From: Ian Lucas ilucas@smitherspurslow.com
Subject: RE: 51/2016/0882 - IWL - Manchester Jewish Museum: Vestibule Floor
Date: 30 November 2020 at 13:07
To: Candice Moore candice@citizensdesignbureau.net
Cc: Katy Marks (Citizen Design Bureau Architects) katy@citizensdesignbureau.net

Manchester Jewish Museum: Vestibule Floor

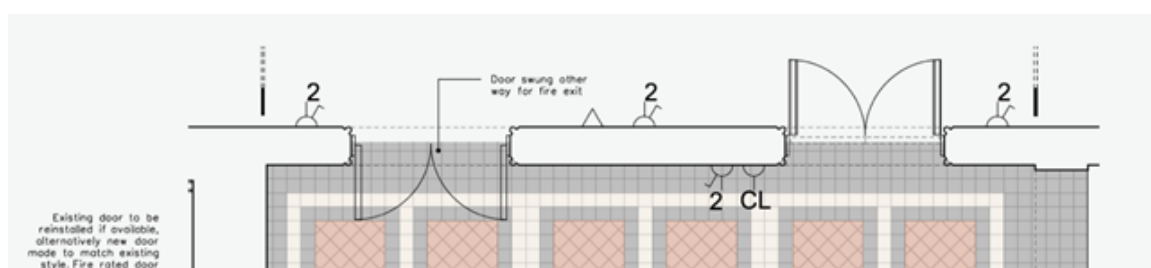
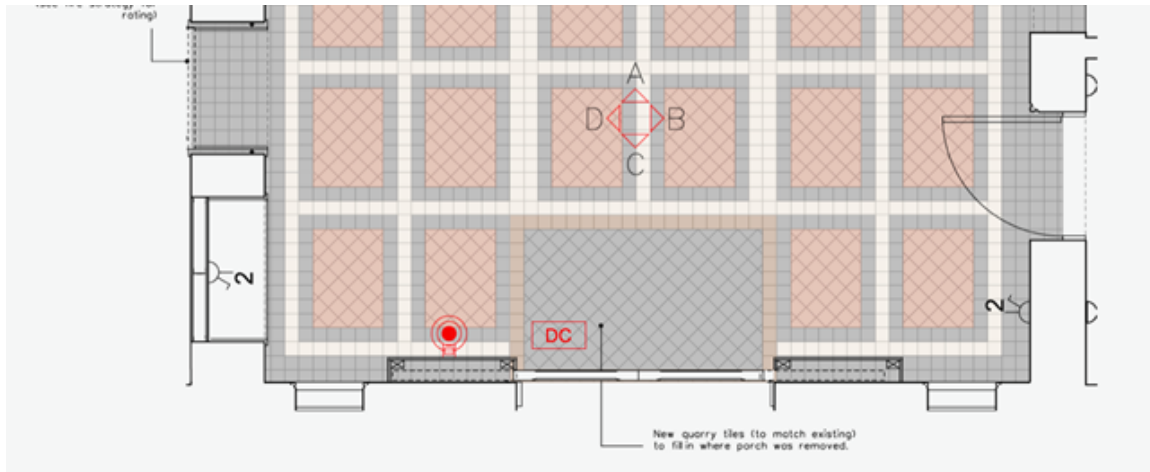
Further to your response below I just wanted to highlight that the new inlay tiles would be done so they look like a welcome mat and rather than trying to blend in.

They will also be laid at a 45degree angle rather than laid in the same grid.

See below our intension.

Is this something you could support?

Thank you for your emailed note of earlier today. I absolutely approve of the proposal to install the new tiling to resemble a welcome mat... and to treat it differently but to the same quality as the remainder of the tiling. This is an excellent approach to historic fabric.
